PLANNING & ZONING BOARD (PZB) RIGHT-OF-WAY VACATION APPLICATION

RE: Right-of-Way Vacation Application
West Village

CITY SUBMITTAL - PZB REVIEW FOR WEST VILLAGE ROW VACATION

Based on your DRC Review comments dated March 26, 2019 Keith and Associates (K&A) offers the following responses to your comments/questions:

Storm Atlas

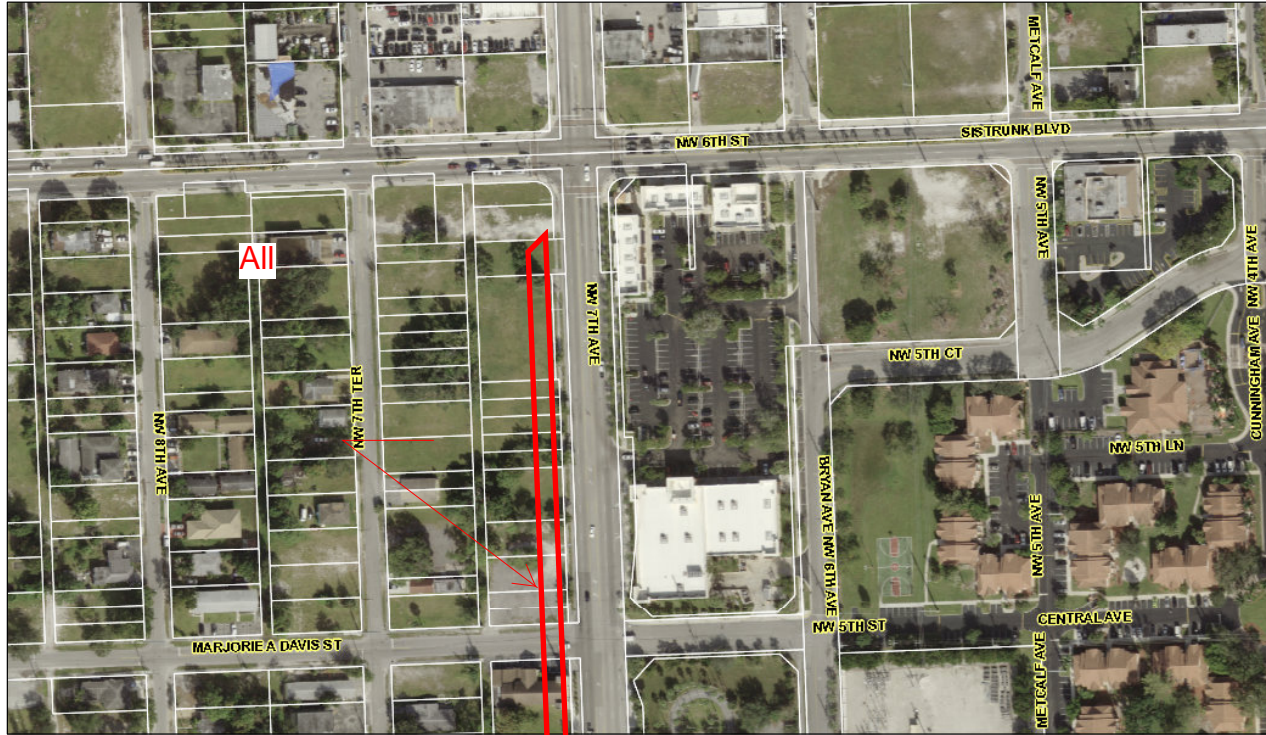
2. Verify that the existing City storm/drainage pipes located on the north and south sides are within the Right-of-Way to be vacated. The minimum Utility Easement the City will accept is 15-feet x 15-feet. The Engineer-of-Record shall provide a letter acknowledging the dedication of the 15-feet x 15-feet (on the north and south sides within the Right-of-Way to be vacated) for the Utility Easement.

RESPONSE: Per the Atlas attached from City of Fort Lauderdale, survey and subsurface utility investigation, there are no existing City storm/drainage pipes located on the north and south sides within the Right-of-Way to be vacated.

ALTA/NSPS LAND TITLE SURVEY

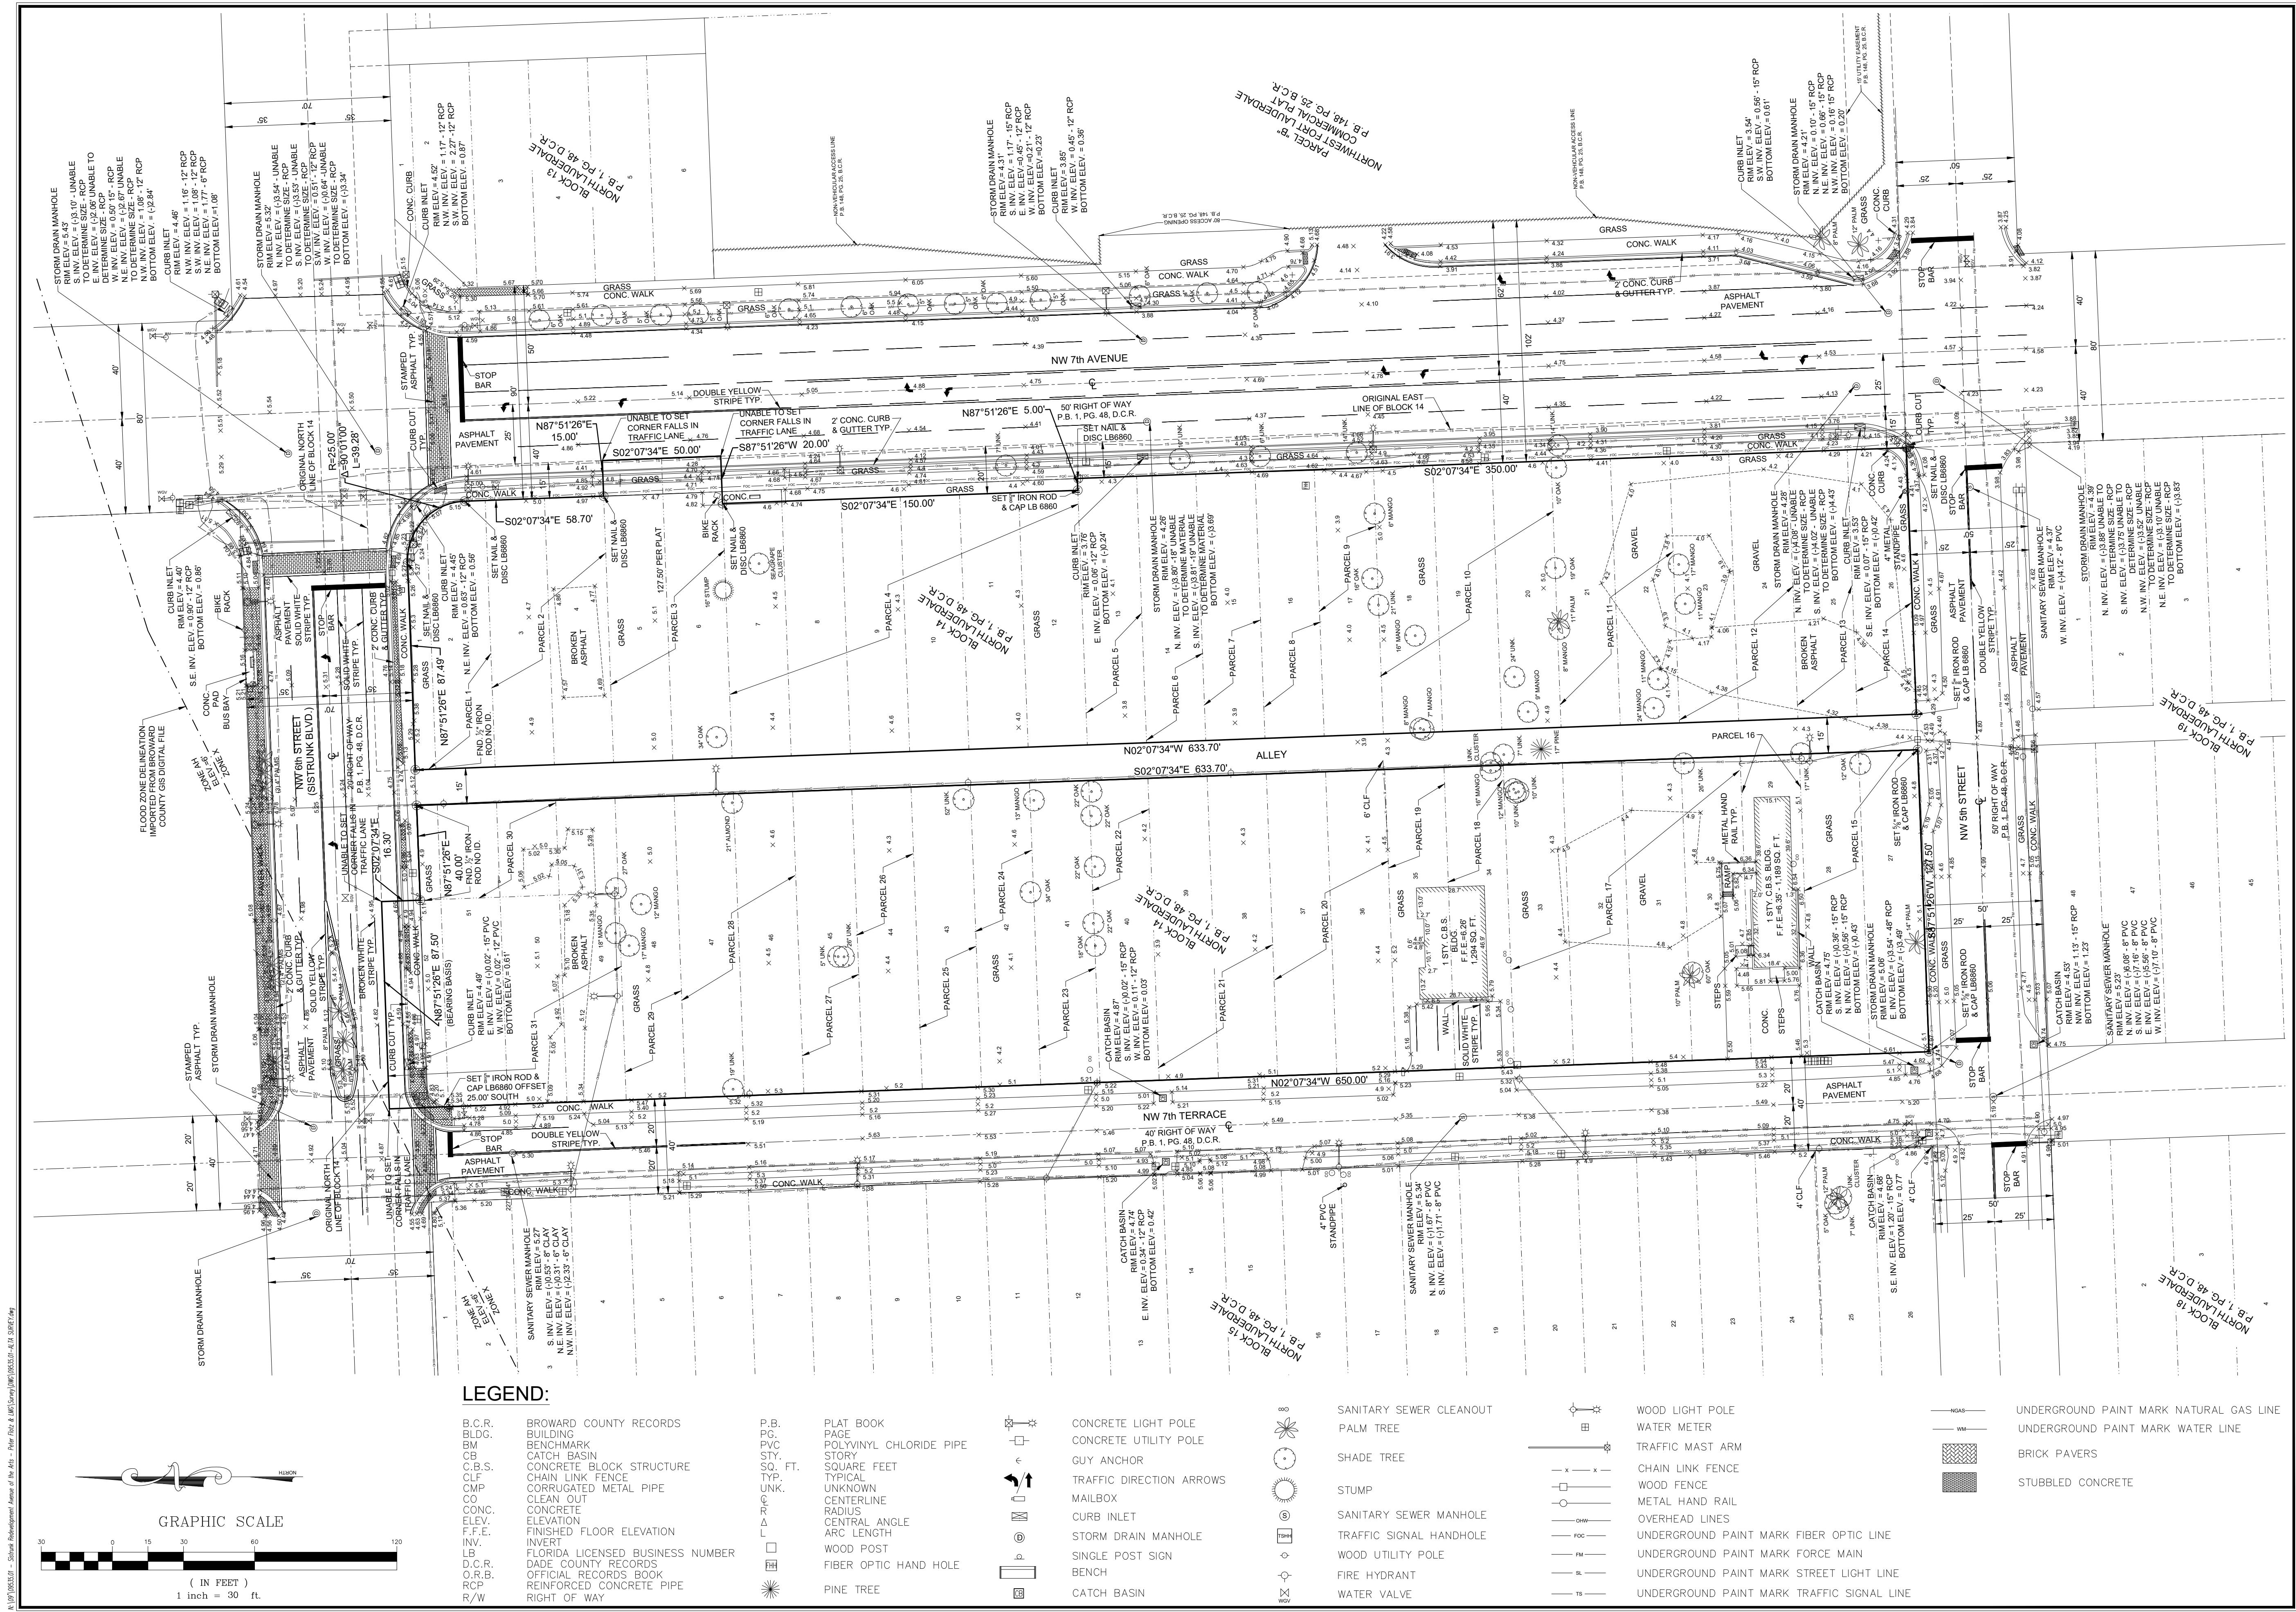
2. Provide a signed and sealed boundary and topographic survey showing all above ground improvements, utilities, rights of way dimensions and all easements. This survey shall be based on a Standard Title Commitment issued by a title insurer licensed to do business in Florida or an Opinion of Title issued by an attorney admitted to the Florida Bar.

RESPONSE: See attached ALTA/NSPS LAND TITLE SURVEY.
